**DOMINION ENERGY KEWAUNEE, INC.**  
**KEWAUNEE POWER STATION**  
**REVISION TO KEWAUNEE POWER STATION EMERGENCY PLAN**

Kewaunee Power Station  
Emergency Plan (Rev. 36)

**Kewaunee Power Station  
Emergency Plan  
Revision 36  
June 30, 2011**

## Revision Summary

**FIGURE 2-1**  
**Interrelationship Of Overall Emergency Response Organization**

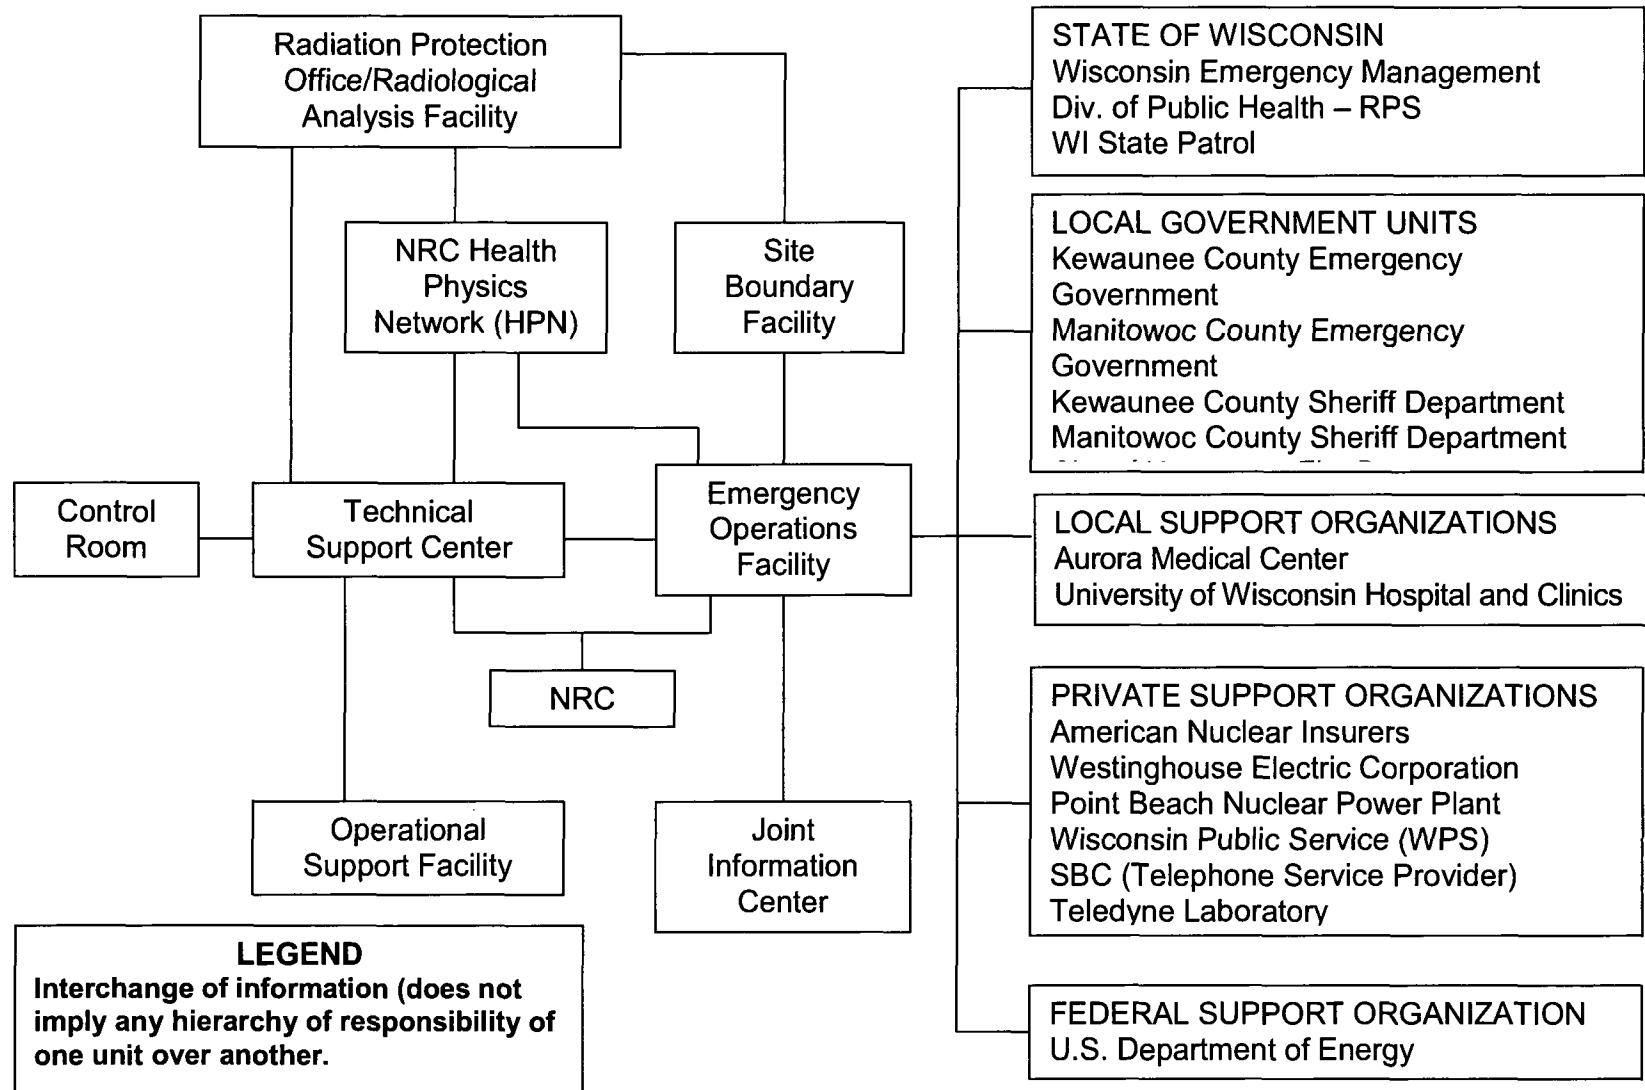
1.1 and 2.2.1	Nuclear Administrative Directives (NAD)	Administrative Procedures	Dominion Fleet administrative procedures have replaced the NADs.
Figure 2.1	HPN was shown as connected to RPO/RAF only	HPN shown connected to RPO/RAF, TSC, and EOF	HPN Phones are located in each of these facilities.
